CITY OF PORTLAND, MAINE
HISTORIC PRESERVATION BOARD

HISTORIC PRESERVATION BOARD AGENDA

June 1, 2016, 5:00 p.m.

ATT. 3a
EXCERPTS
FROM MARCH 16
SUBMISSION

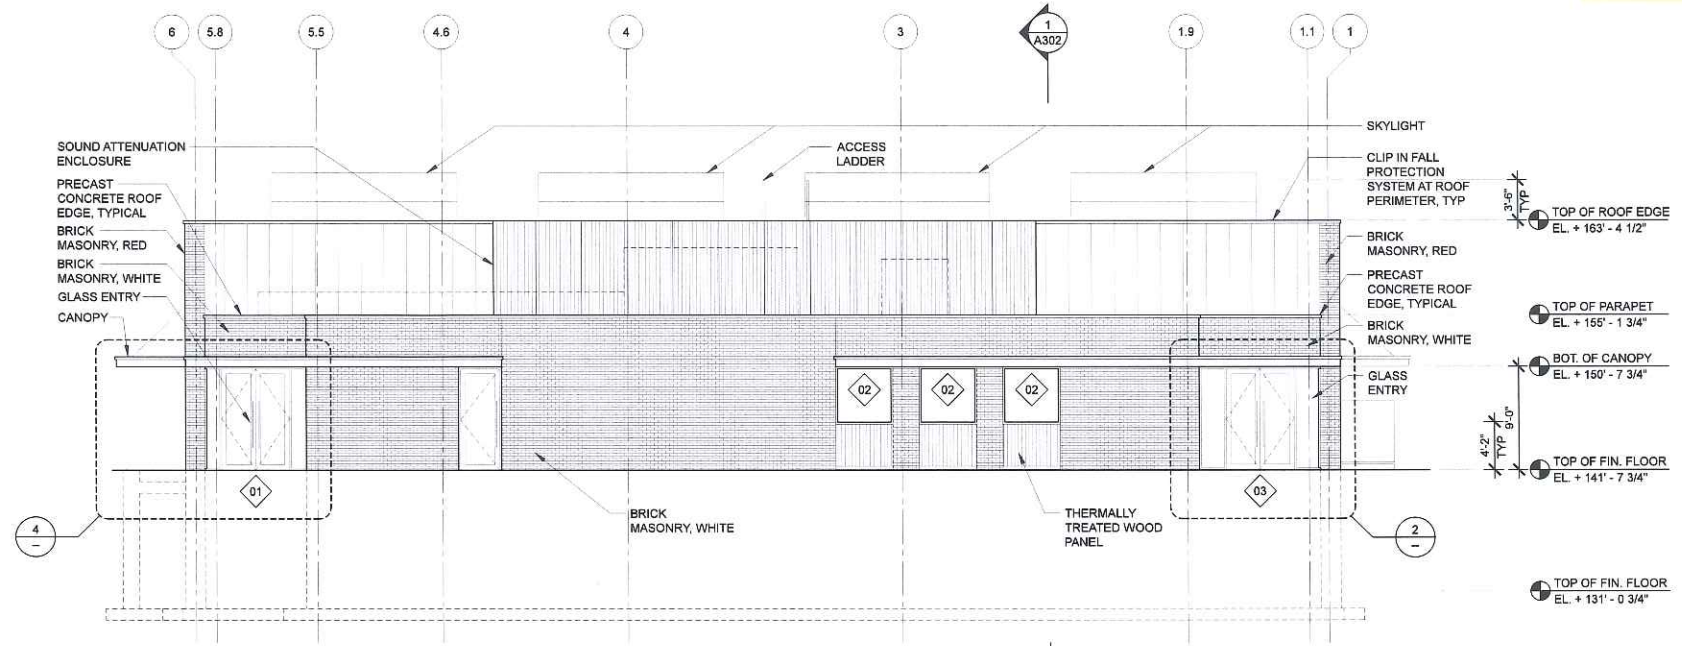
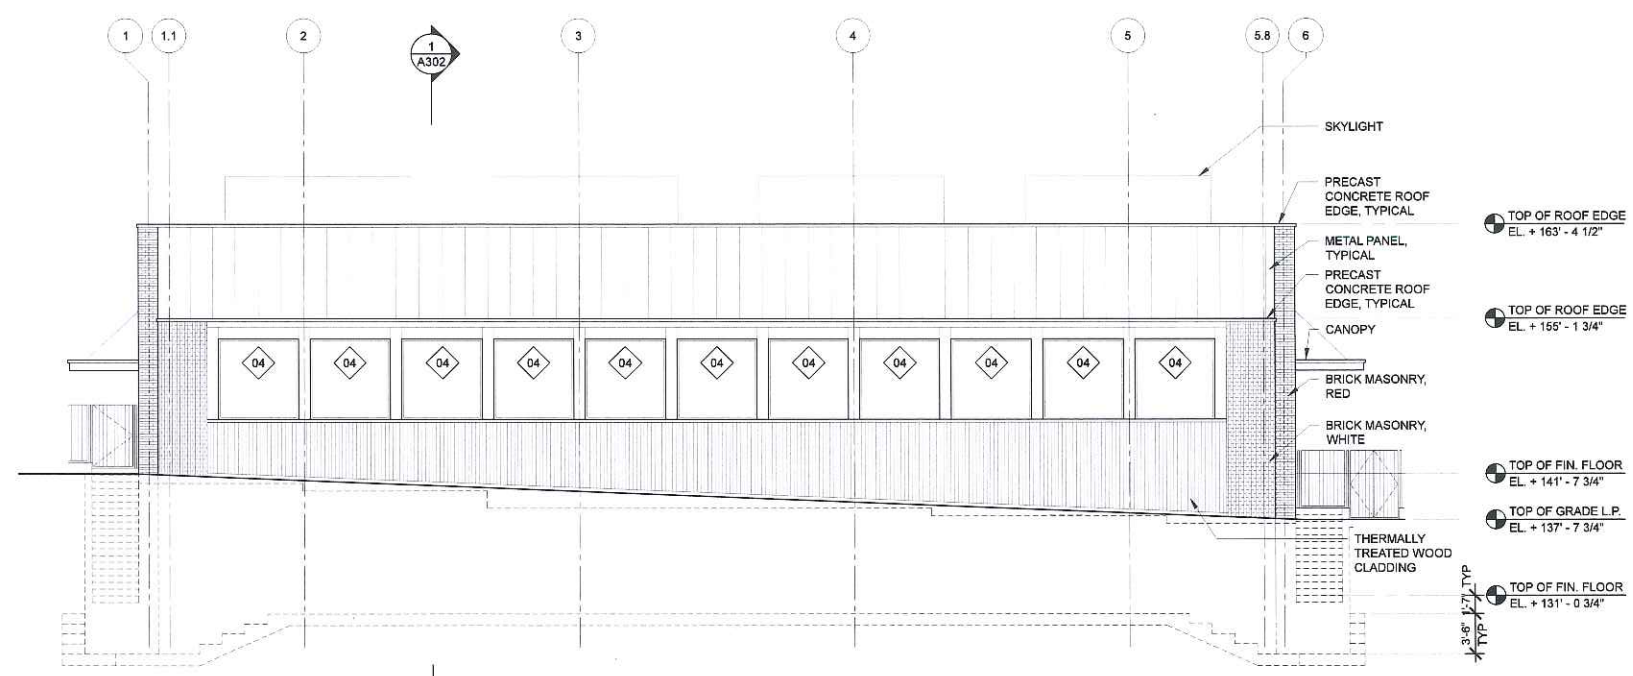
Among the concerns identified was the proposed use of natural wood siding for the base of the façade. Board members found that natural wood siding was not appropriate in this context of this high style, historic residential structures. Also, given the uncharacteristic size of the building and the fact that the replacement structure will be moved 7' closer to Fletcher Street, Board members argued that further modifications were needed to ameliorate its visual impact on the street. Suggestions included raising the height of the window band to make it less visually prominent; subdividing the glazing to achieve "finer grain" fenestration; installing self-darkening glazing or window treatments to reduce light emittance from the gym during evening hours; landscaping against the building and planting trees closer to the street edge. Some Board members also suggested installing a sidewalk along the applicant's stretch of Fletcher Street to further integrate this portion of the street with prevailing development pattern. In general, Board members encouraged that the Fletcher Street frontage read much like a recessive garden wall.

Since the March workshop, the project architects have revised the material palette of the gymnasium and modified its fenestration on the Fletcher Street façade. The site treatment in front of the Fletcher Street elevation has also been revised. **ATTACHMENT 1** is a list of all the elevation or plan views that have revised as a result of the most recent design modifications. Added drawings and perspective views are identified as well. The added illustrations pertain to the condition of approval that must be addressed at this time. (See following section of this report for more information on this subject.)
